- **DRIVEABILITY—LOSS OF POWER AND EXTERNAL TURBO OIL LEAK—7.3L DIESEL**
- **ENGINE—7.3L DIESEL—LOSS OF POWER AND EXTERNAL TURBO OIL LEAK**
- **NOISE—EXHAUST NOISE FROM TURBO—7.3L DIESEL**

**Article No.  
03-21-49**

**FORD:** 1999-2001 E SERIES, SUPER DUTY F SERIES  
2000-2001 EXCURSION, F-650, F-750

Figure 1 - Article 03-21-49

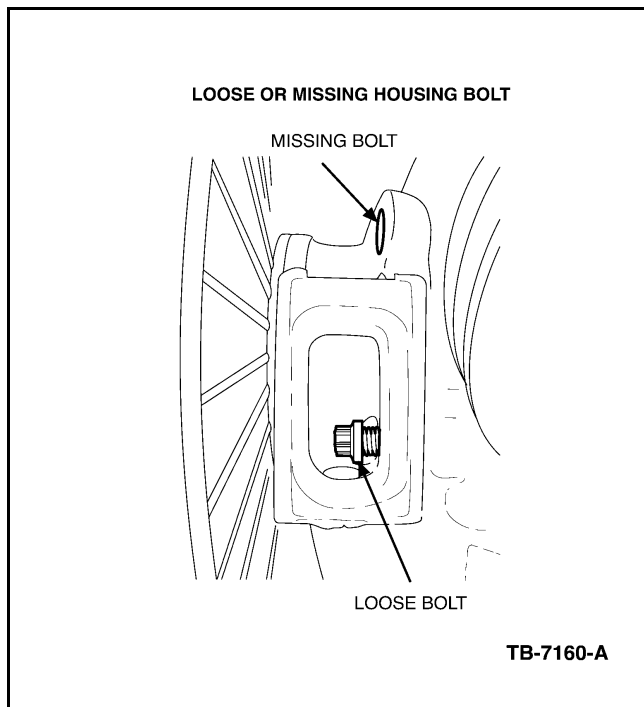
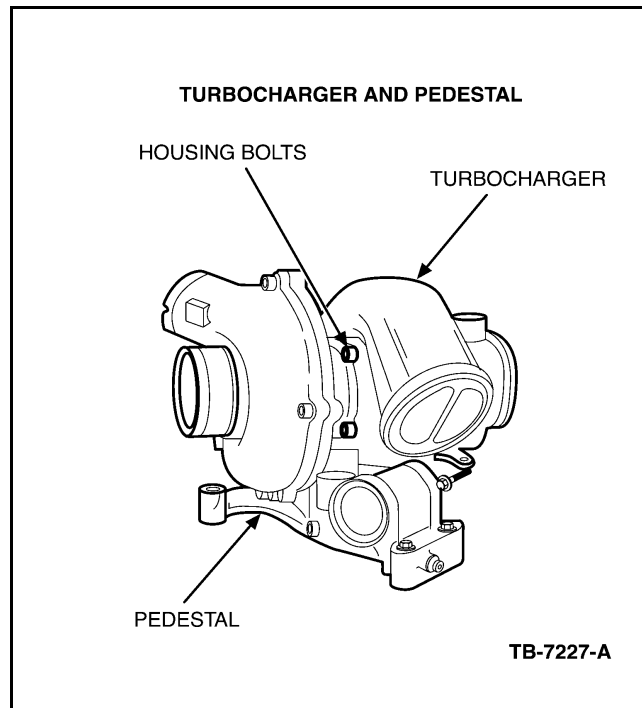
Visually inspect the turbo housing for loose or missing turbo housing bolts (Figures 1 and 2). If turbo housing bolts are loose or missing, use Turbo Housing Bolt Kit 1C3Z-9G486-AA to replace the bolts. The new bolts are torque prevailing bolts (Figure 3).

3. Clean internal threads in the turbine housing.
4. Install new bolt and torque to 360 lb-in. (41 N•m).
5. Repeat Steps 2-4 for the remaining 3 bolts.
6. Inspect the reusable oil feed and oil drain O-rings between pedestal and turbo for damage. **REPLACE ONLY IF THE SEAL IS DAMAGED.**
7. Lubricate O-ring seals with clean engine oil prior to re-assembly
8. Follow appropriate model year Workshop Manual Section 303-04 procedure to reinstall the turbo.
